Product Change Notification

108464 - 00

Change Notification #: 108464 - 00
Change Title: DP35DP, PCN 108464-00, Product Design, BIOS Update, DIMM connector change, and alternate audio connector
Date of Publication: June 12, 2008

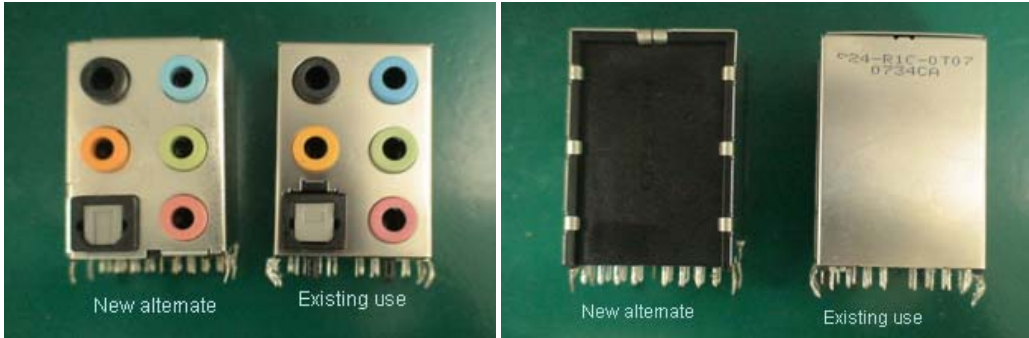
The DIMM connectors are being replaced with enhanced versions from the same vendors.
